ADDENDUM No. 1

REQUEST FOR QUOTATIONS No.: 1220-040-2022-080

TITLE: Sump Pump Installation at Surrey Archives

ADDENDUM ISSUE DATE: October 14, 2022

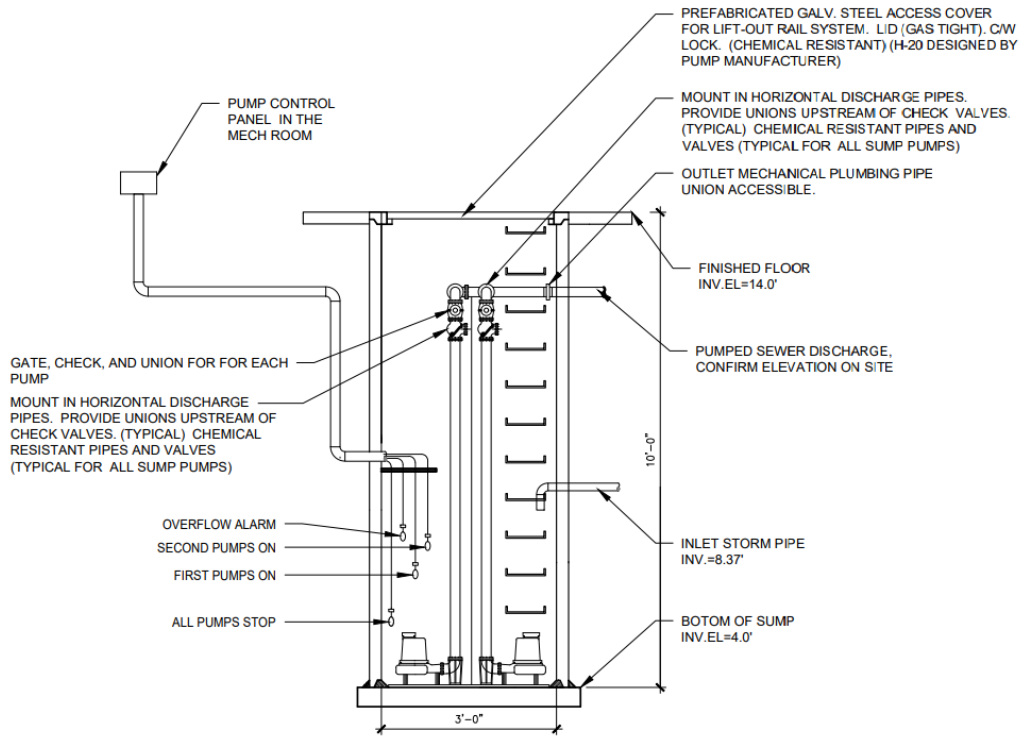
Q1. In the drawing package there are two elevation drawings for the sump. One is concrete with an H2O (vehicle loading) hatch and other is for a fiberglass basin. Can you confirm which type of basin will be used?

A1. The construction of the pump basin shall be of concrete construction, concrete with an H20 (vehicle loading) hatch.

3 STORM PUMP SUMP DETAIL
SCALE: N.T.S.

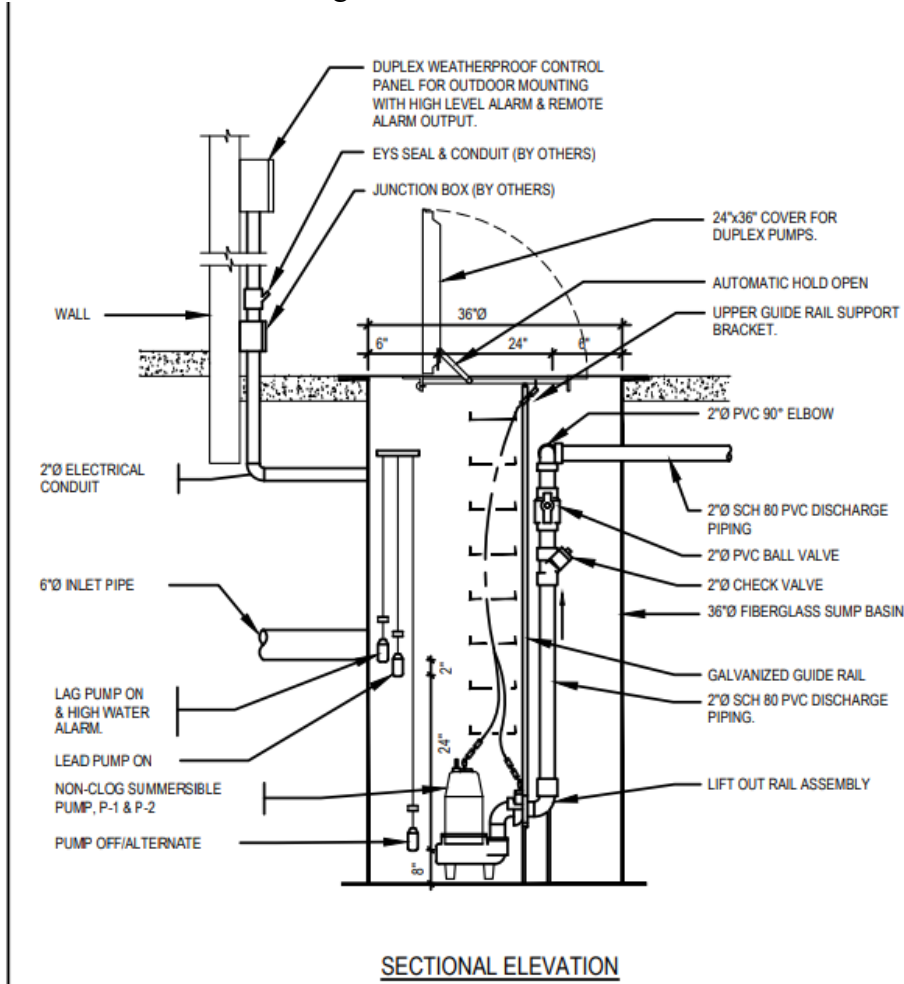
and the other is for a fibreglass basin:
